To: Mr. Bill Uhrich  
Simcic + Uhrich Architects  
Suite 230 3 West 3rd Avenue  
Vancouver BC V5Y 3T8

Submitted: May 18, 2017 by  
RDH Building Science Inc.  
730 Grant Avenue #208  
Courtenay BC V9N 2T3

RDH Building Science Inc. (RDH) was retained by Simcic + Uhrich Architects to undertake a targeted investigation of the of the wall assembly located at 3850 Central Rd, Hornby Island, BC.

TABLE 1.2 DESCRIPTION OF BUILDING	
Name	Hornby Island Fire Hall
Address	3715 Central Road Hornby Island, BC
Date of construction	2016
Applicable building codes	BCBC 2012
Building code classification	Part 5
Number of storeys	2
Type of construction	Wood frame
Structural system	Concrete foundation

*Figure 2.3*

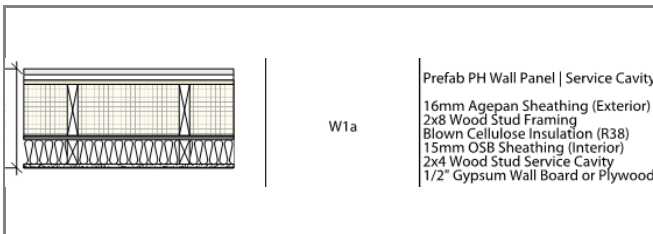
As reported to us, the walls of the Passive House equivalent portion of the fire hall are constructed from premanufactured wall panels as shown in the figure below. The air barrier and vapour barrier are formed by the OSB interior sheathing with taped joints between panels and joints in the OSB sheets. An Ampatop Aero synthetic water resistive barrier was site installed over the exterior Agepan sheathing. We did not review these walls during our site visit.

It is our understanding that the interior OSB sheathing was intended to form the vapour retarder and air barrier for the wall assembly, however we understand that the joints in the OSB were not taped during construction and plywood sheathing was used along the top of the wall due to product availability.

*Figure 2.9*

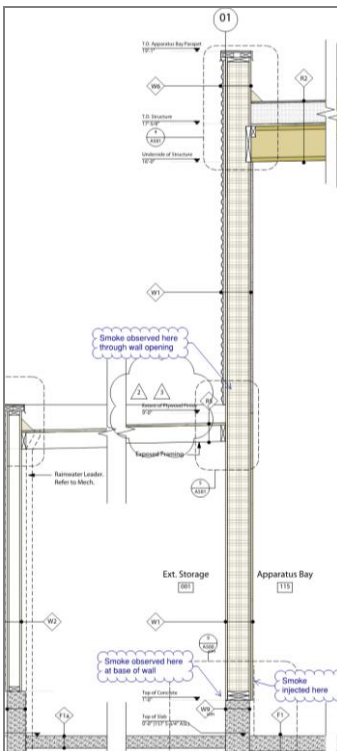
- We performed smoke testing of the wall assembly at targeted locations including the two interior electrical outlets at the base of the wall. Smoke was injected past the outlet using a Rosco 1900 fog machine. No pressure differential was imposed on the wall other than ambient weather conditions. The smoke was forced into the wall with an inline fan within the 4 inch smoke tube. When smoke was injected past the interior outlet at Gridline 1/C smoke was observed in the stud cavity above the unheated storage room, refer to Figure 2.9.

*Small amount of smoke observed at the blocking in the stud wall above the storage roof during the smoke test at the interior outlet below.*

*View from the exterior opening above the unheated storage room.*

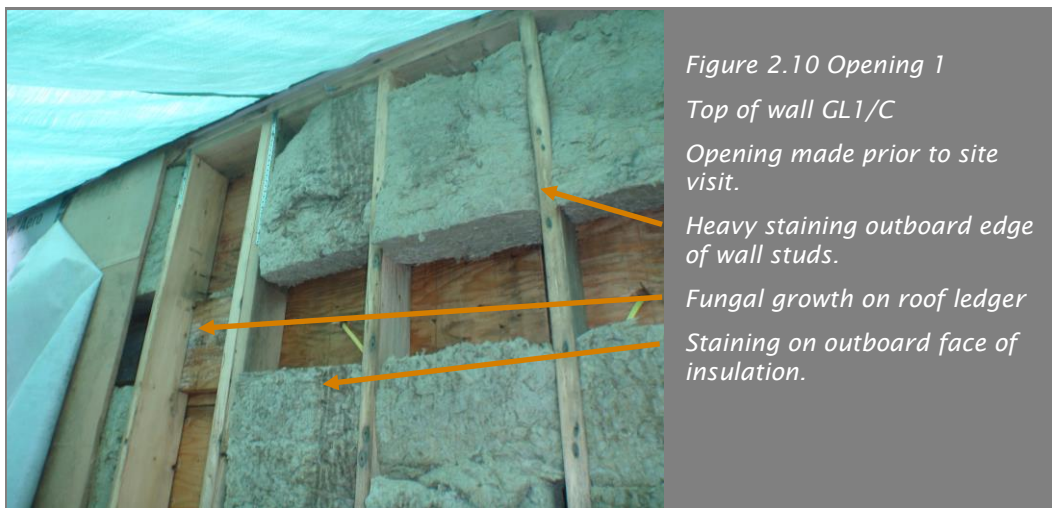
During our site visit on May 01 2017, IWCD made 5 openings through the exterior cladding and water resistive barrier to view the condition of the Agepan Sheathing and the stud cavity. One opening above the unheated storage was already made prior to our site visit. The following observations were made at each opening.

Opening 1 was made by IWCD prior to our site visit and as a result of staining observed at the base of wall below the opening. IWCD indicated that wet insulation and studs were observed when the wall assembly was opened up.

*Figure 2.11 Opening 2  
Top of wall GL 1/G  
Moisture Content Readings  
40% MC plywood at parapet  
40% MC back side of Agepan  
Wet insulation  
25% MC outboard face of stud*

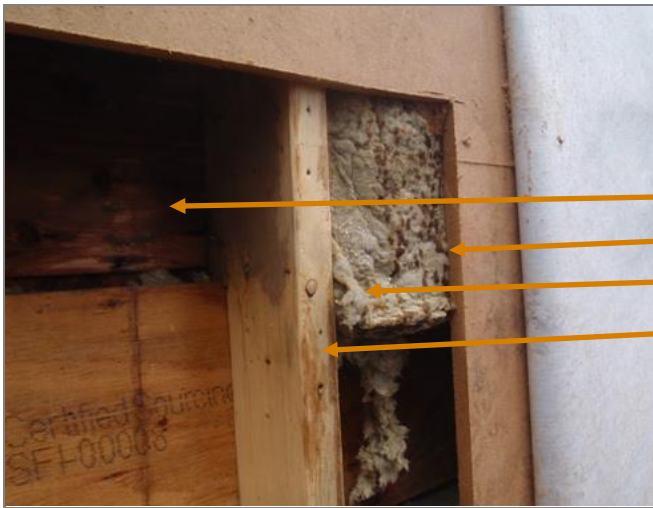
This exploratory opening was made by IWCD during our site visit. The opening was made at the parapet height near the roof level interface. We observed moisture droplets on the face of the mineral wool insulation. The moisture content in the plywood sheathing on the inside face of the parapet was found to be 40% indicating the wood is saturated. The majority of the parapet plywood would be cold due to the uninsulated inside parapet face above the roof level.

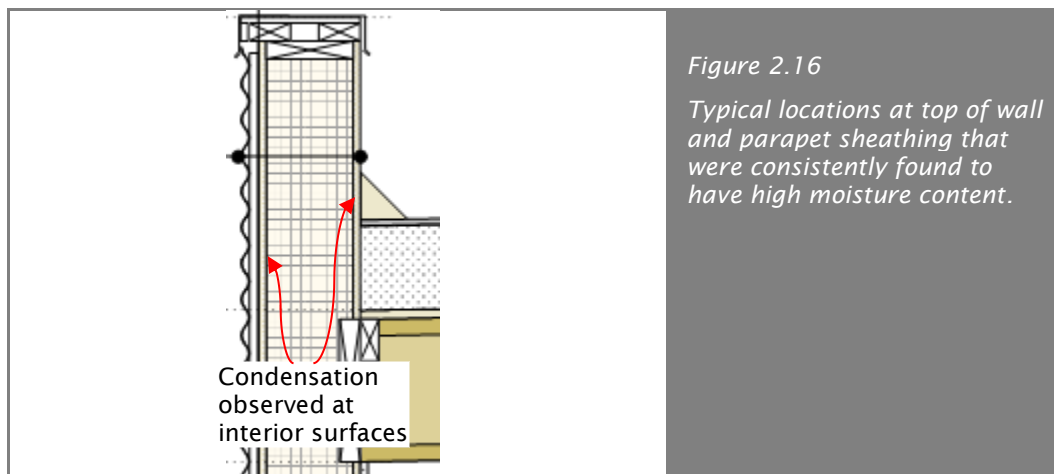
Varying levels of staining and fungal growth on the in-board side of the Agepan was identified at all exploratory openings indicating there was moisture accumulation to some degree across the entire wall area. The moisture has now accumulated at the top of the wall condensing on the inboard side of the Agepan sheathing and parapet sheathing, refer to Figure 2.16.

- The wall needs to be dried out.
- The fungal growth should be cleaned/removed from affected materials.
- Provide a continuous air barrier system within the apparatus bay walls and interfaces to the adjacent assemblies such as foundation wall and adjacent fire hall walls. Including provisions to reduce convective looping into cold parapet spaces.
- Review and provide appropriate vapour control strategy for the apparatus bay wall.

- Dry out the wall.
  - At the Apparatus Bay walls remove at least the top 6 feet of cladding, Agepan sheathing, and insulation to dry out the interior stud cavity.
  - Clean and treat all fungal growth from within the wall cavity and dispose or clean all Agepan sheathing with existing staining or fungal growth.
- Correct air barrier discontinuities and provide vapour control.
  - Seal penetrations through the interior wall finishes including outlets and fixtures. This can potentially be performed from the exterior side of the interior sheathing or at the interior of the Appartus bay space by sealing the sheathing .
